Re: Crane Drive
Applicant: Christopher Shaughnessy
Subdivision Modification and Waiver Request

On behalf of the Applicant, Morse Engineering Co., Inc. respectfully requests a modification to the definitive subdivision known as Crane Drive. Submitted herewith are the following:

**APPLICATION FOR MODIFICATION, RESCISSION OR AMENDMENT OF
DEFINITIVE SUBDIVISION PLAN**

Figure 20-S-1777

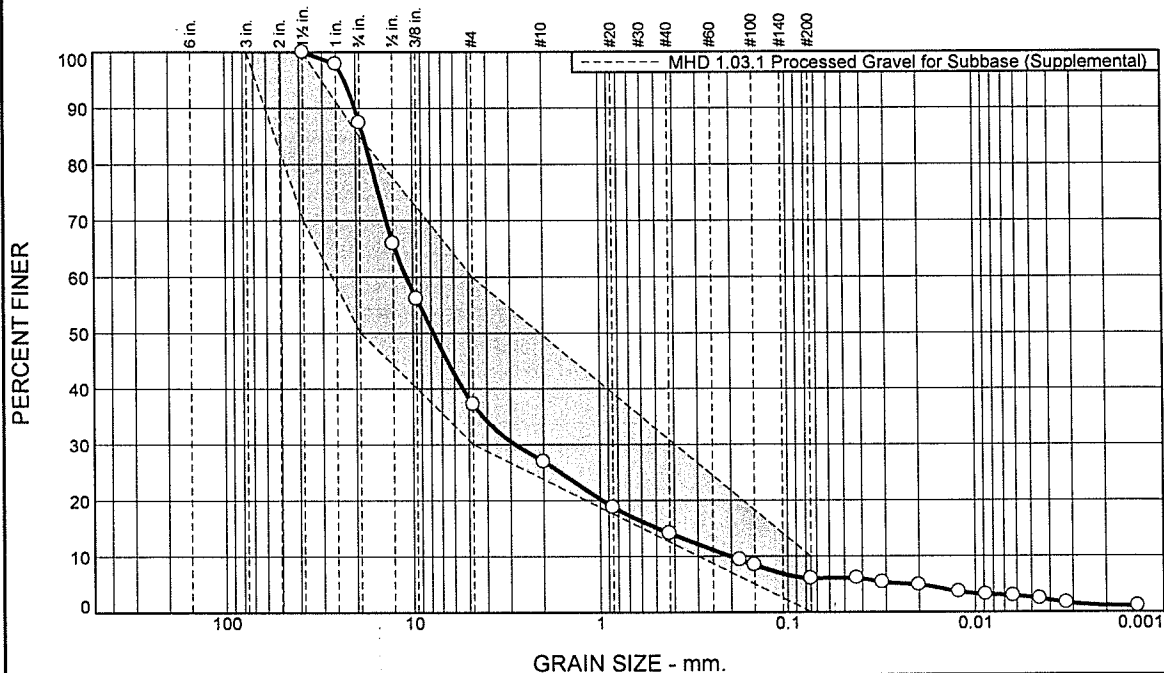
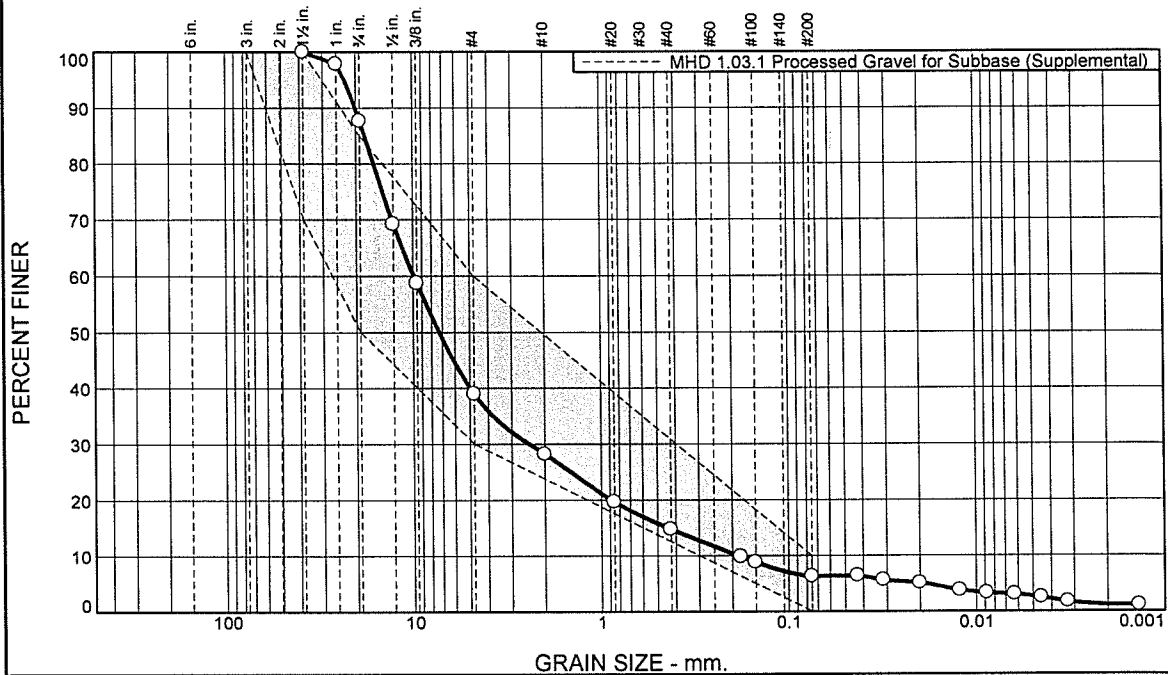
1. The gravel subgrade material installed during the second lift did not comply with the ¾ inch sieve for the MassDOT M1.03.1 specification. Therefore, a waiver is requested from Section 5(J3) of the Planning Board Rules and Regulations to allow the gravel base material per the following gradation:

Justification: The material was field tested for compaction and exceeded the project specifications. The material installed during the first lift did comply with the M1.03.1 specification. The material installed during the second lift came from the same source but did not comply.. It was sampled and tested in two locations, and both did not comply with the ¾ inch sieve only. The material was re-tested, and one of the samples passed.

Sieve Designation	MassDOT M1.03.1 Percent Passing	Requested Waiver Percent Passing
3 in.	100	100
1 ½ in.	70-100	70-100
¾ in.	50-85	50- <u>87.7</u>
No. 4	30-60	30-60
No. 200	0-10	0-10
